MIL-C-39029/44D
AMENDMENT 2
31 December 1990
SUPERSEDING
AMENDMENT 1
15 September 1989

MILITARY SPECIFICATION SHEET

CONTACT, ELECTRICAL CONNECTOR, PIN, CRIMP REMOVABLE
(FOR MIL-C-5015 SERIES MS3400 CONNECTORS)

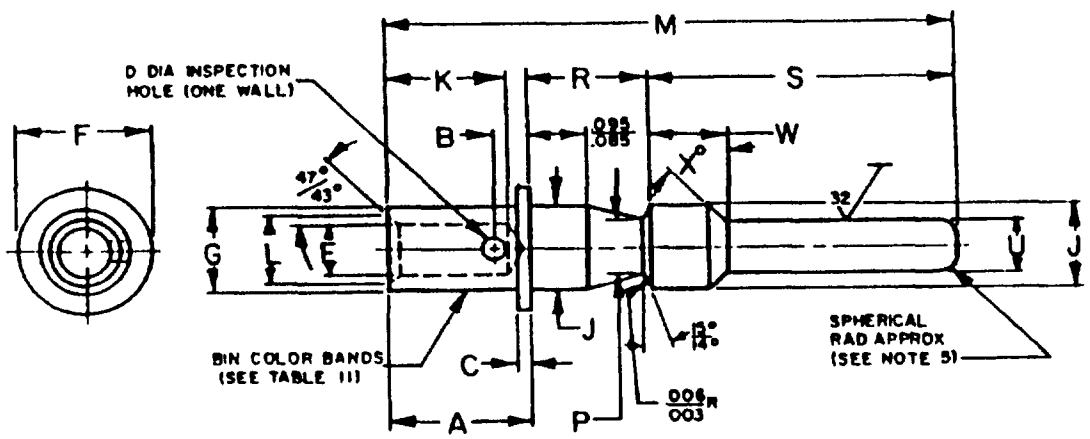
Figure 1, relocate "W" dimension as shown in figure below.
